PCN# : P671AAB
Issue Date : Jul. 12, 2016

Information Only Notification

Figure 7. Breakdown Voltage Variation vs. Temperature (Page 4)

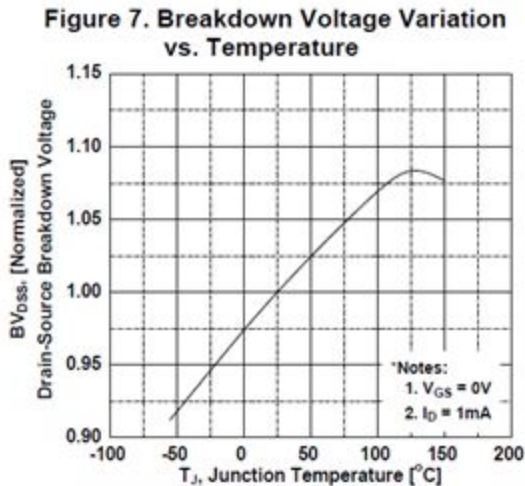
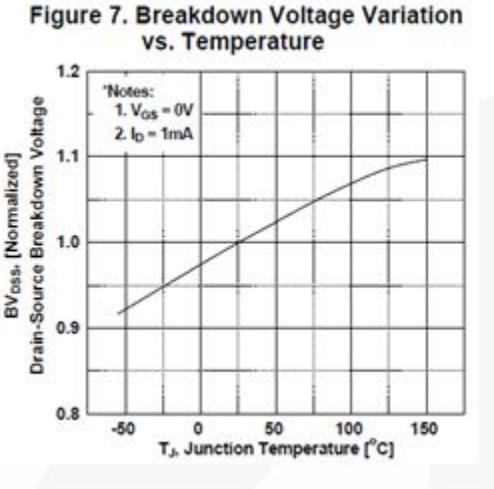
Figure 7. Breakdown Voltage Variation vs. Temperature , updated to correct for 150C temperature measurement.

Correcting a measurement error at 150C temperature readpoint
